SERVICE BULLETIN

APPLICABILITY: 2015-2018MY WRX and WRX STI **NUMBER:** 07-139-18R
SUBJECT: LED Headlamp Deformation -Design Change **DATE:** 08/09/18
REVISED: 08/24/18

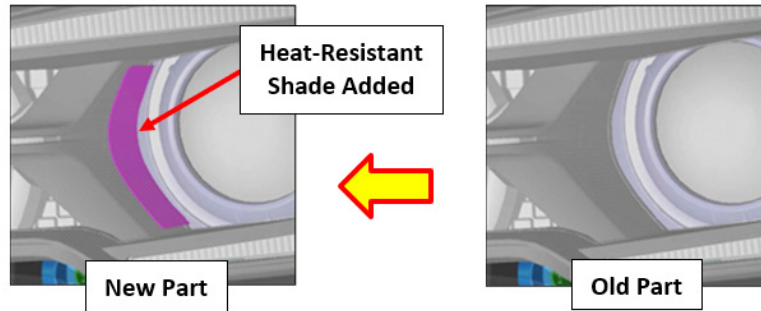
This bulletin outlines a design change made to the inner lens extension portion of the LED headlamp assembly. Under the right conditions, the shape of the lens for the actual head lamp light source can cause sunlight to be focused onto the extension portion of the lens resulting in deformation. A heat-resistant shade has been added to protect the affected area.

The images below show the affected area of the lens where the deformation can occur along with a comparison between the new style lamp with the shade added and the original.
